The Secretary
Department of Planning and Environment
Level 22, 320 Pitt St
Sydney NSW 2000

Metz Solar Farm (SSD 7931) - Modification Application 1 – Increase solar array height

Figure 1: Single axis tracker height differential approved and proposed height

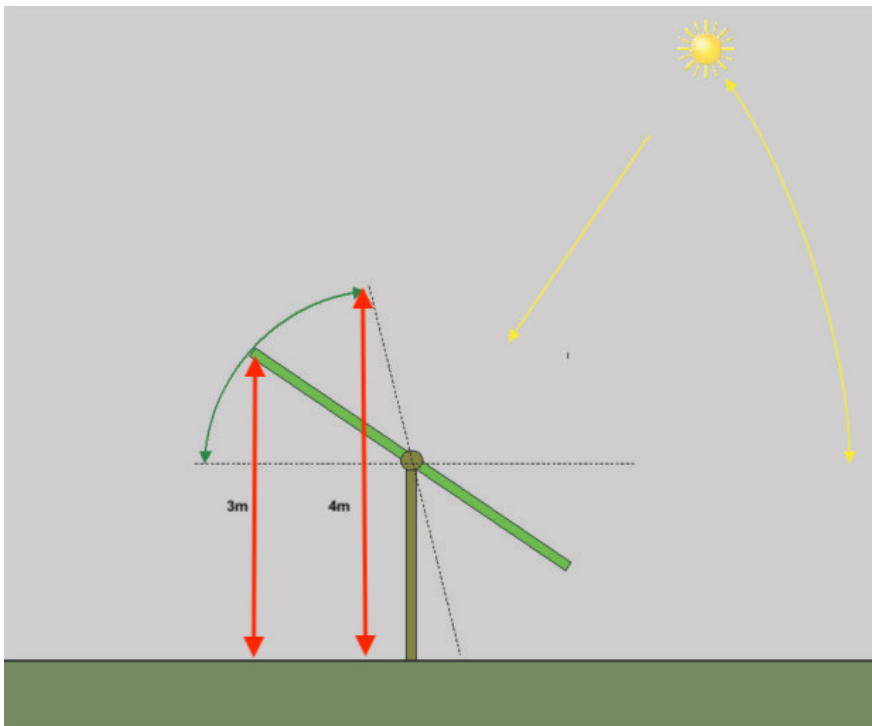
The proposed modification shall enable the solar arrays to be operated in a manner that increases their maximum height above ground level from 3 metres to 4 metres. .

Under the proposed modification, solar arrays would exceed the approved maximum height of 3 m at the beginning and end of each day (as well as being stored in this position overnight), when tracking the sun at low incidence angles, effectively increasing the maximum height of the arrays to 4 metres as shown in Figure 1 below. Under the modification, the solar arrays would remain below the approved 3 m height for much of the day.

Figure 2 Comparison Indicative Layout from Original Approval versus proposed layout for modification

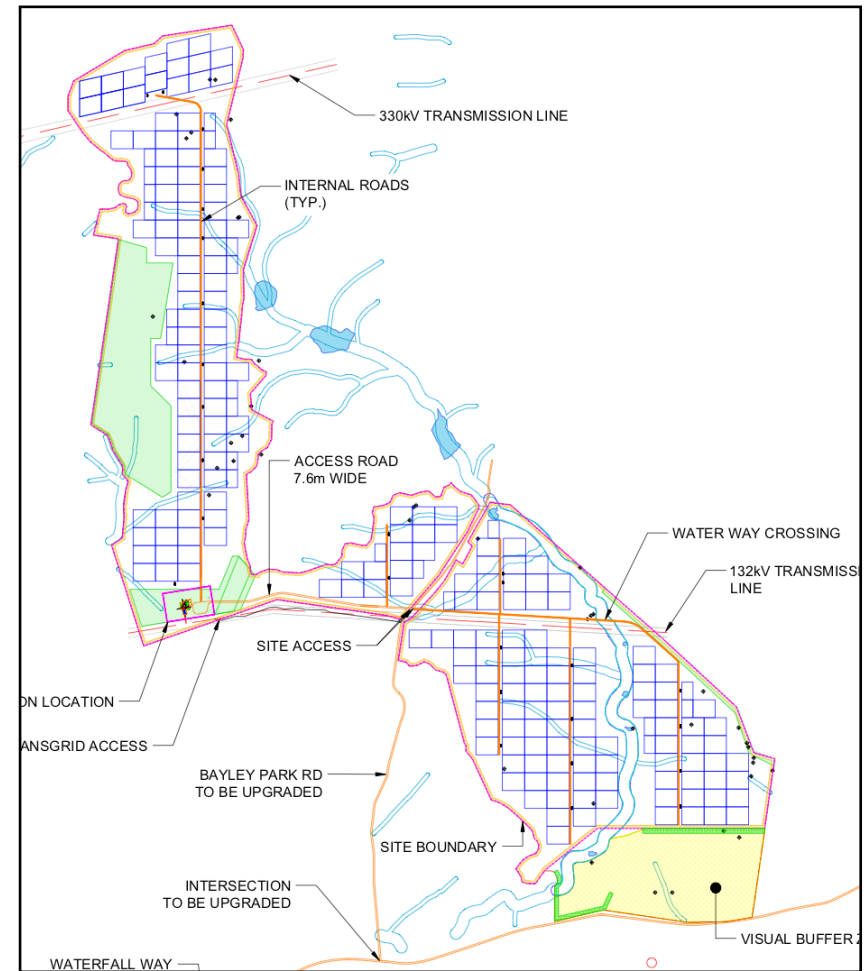
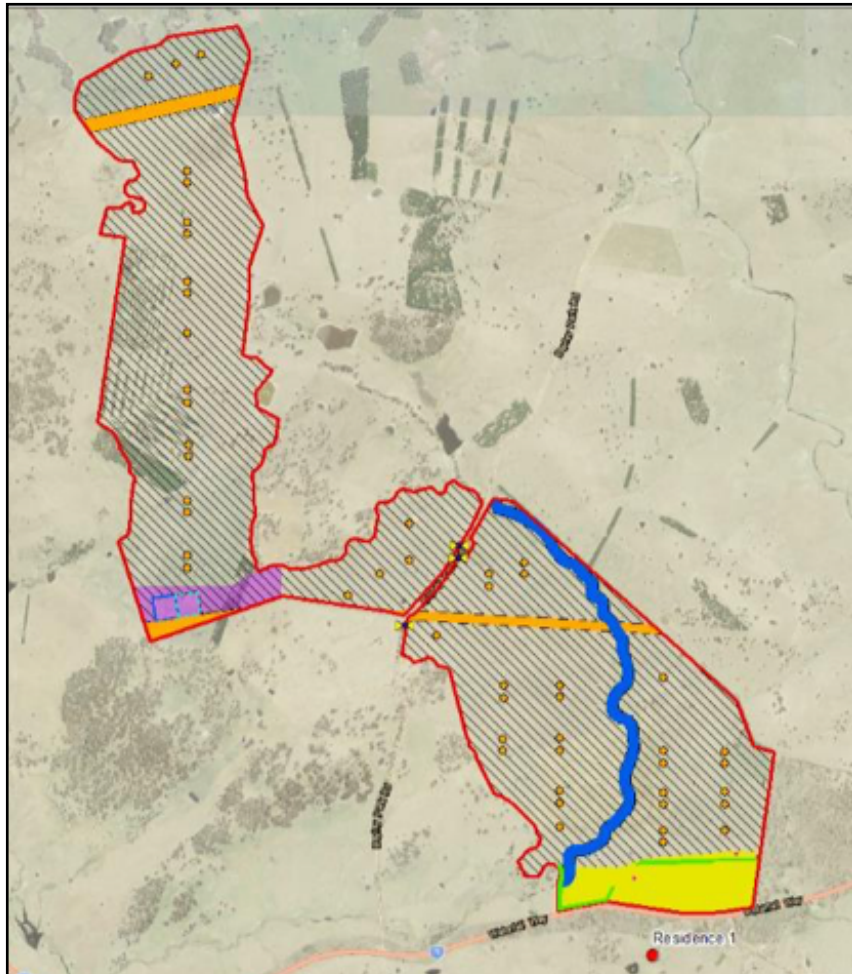
Under the proposed modification, the efficiency and energy output of the Metz Solar Farm shall be increased, whilst enabling a reduced footprint with increased setbacks to further mitigate potential visual impacts associated with the project. The revised Project footprint associated with the proposed modification is shown in Attachment in 1 for reference. Potential impacts of the increased height to nearby sensitive receptors (NSRs) are mitigated through:

- the revised footprint adopting increased setbacks relative to the approved development site boundary and footprint; and
- significant increased setbacks from the relevant southern boundary and vegetation screening to mitigate visual amenity impacts on the nearest visual receptor (R1).

Table 1 below provides a comparative analysis between the originally approved development and the development in its proposed modified form. A comparison of between the indicative layout in the submitted EIS and the layout in the proposed modified form.
